SAVE THE SCENIC SANTA RITAS ASSOCIATION

RE: CLEAN WATER ACT 404 PERMIT FOR THE PROPOSED ROSEMONT COPPER MINE

Figure 3. Peak and base flows in July and August 2017 at USGS gage 09484580. Base flows persisted long after the last measured rain at the gage (August 3, August 15).

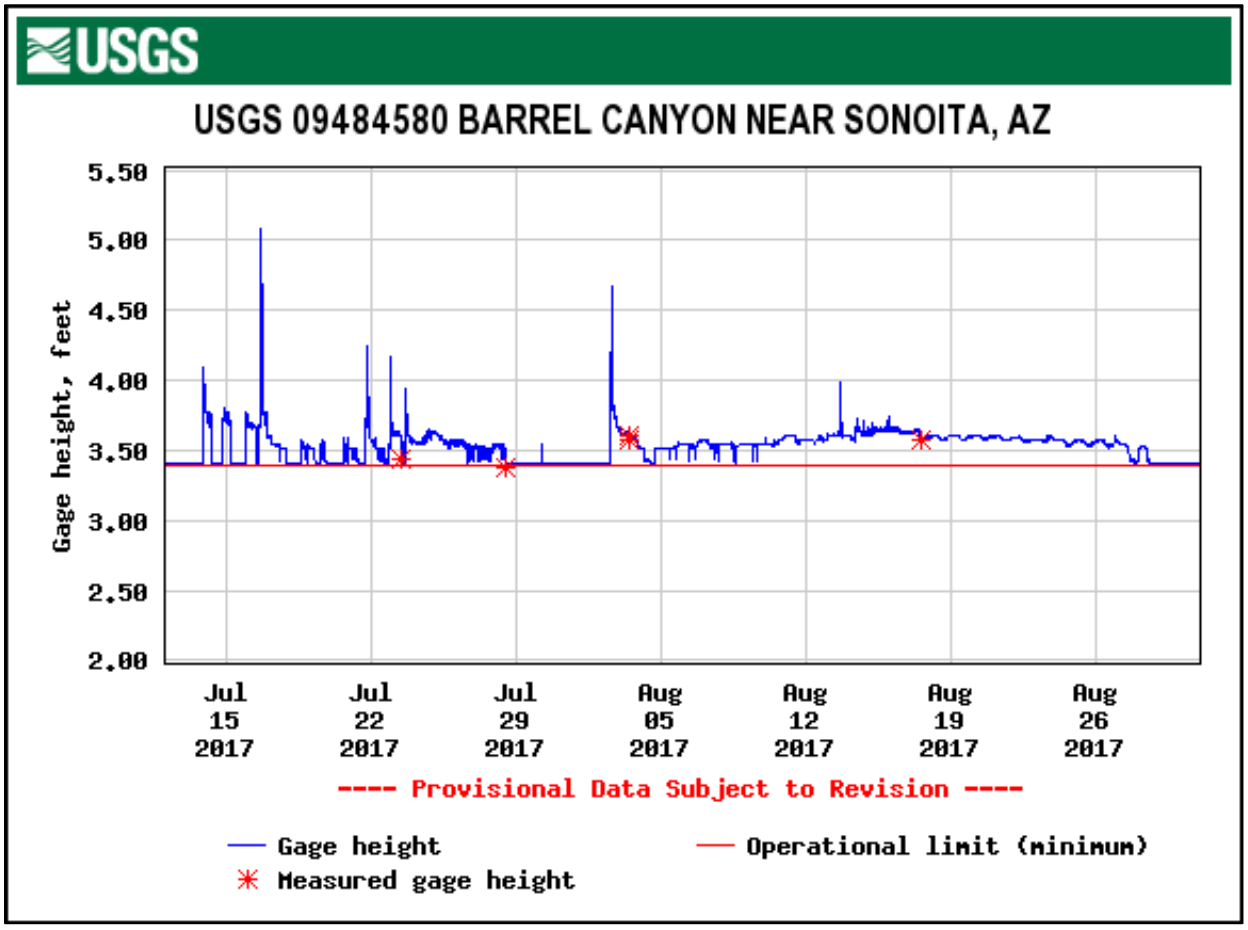
The gage record for the 2017 monsoon season shows two periods with base flows for a number of consecutive days in July and August, shown in the graph below. Red asterisks indicate the date of field observations at the gage by USGS personnel. Storm flows are shown by the sharp rises with a "tail", and the base flows by the relatively stable low flows in between the peaks.

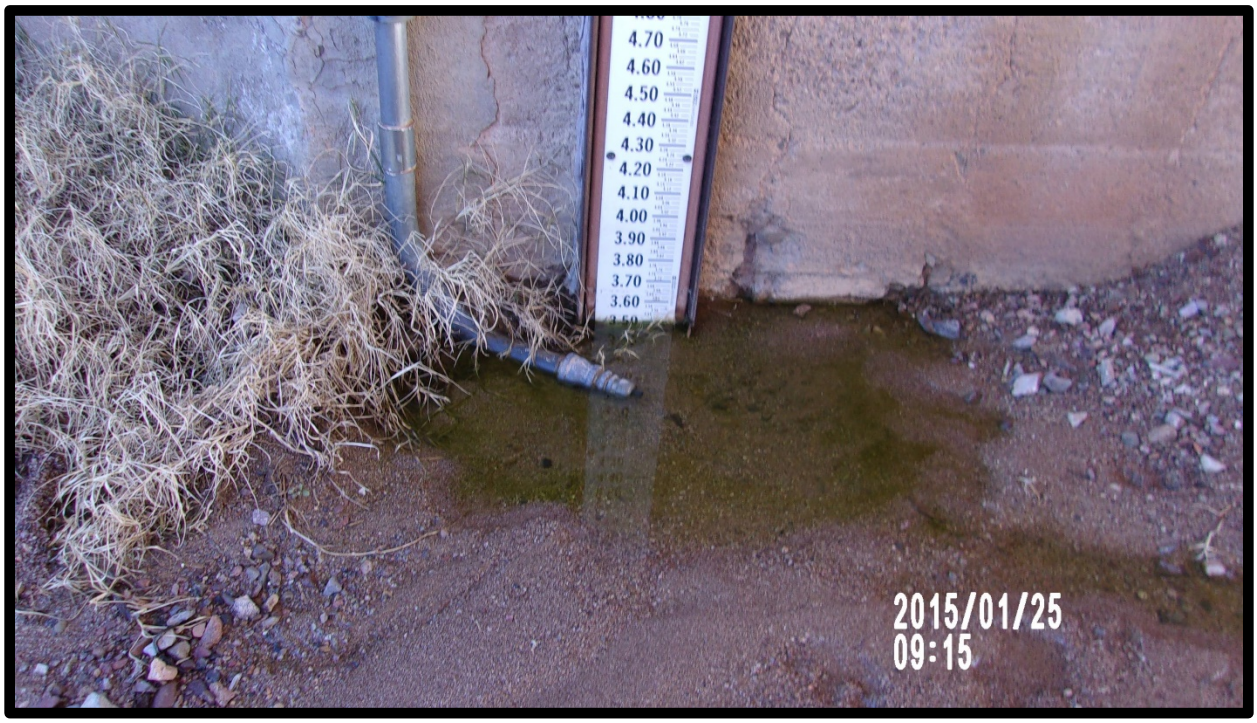
A shallow water table appears to help sustain flows in this intermittent reach. Figure 5 shows bedrock exposures which help to bring groundwater to the surface. Repeated groundwater level measurements have been provided to the Forest Service by Hudbay (2015; Memorandum from Kathy Arnold to Karen Herther, "Water Quality/Water Level data for U. S. Forest Service") both upstream and downstream of the gage. Downstream of the gage, an unnamed well (D-18-16-14dac) shows measurements that fluctuated flow less than one to more than ten feet below land surface over the period 2008 to 2014. Upstream of the gage, groundwater levels in a monitoring well installed by Rosemont (located at D18-16-15dcc) fluctuated from two to three feet below land surface during 2013 and 2014. There is also a recorded spring downstream of the gage, called Barrel Spring.
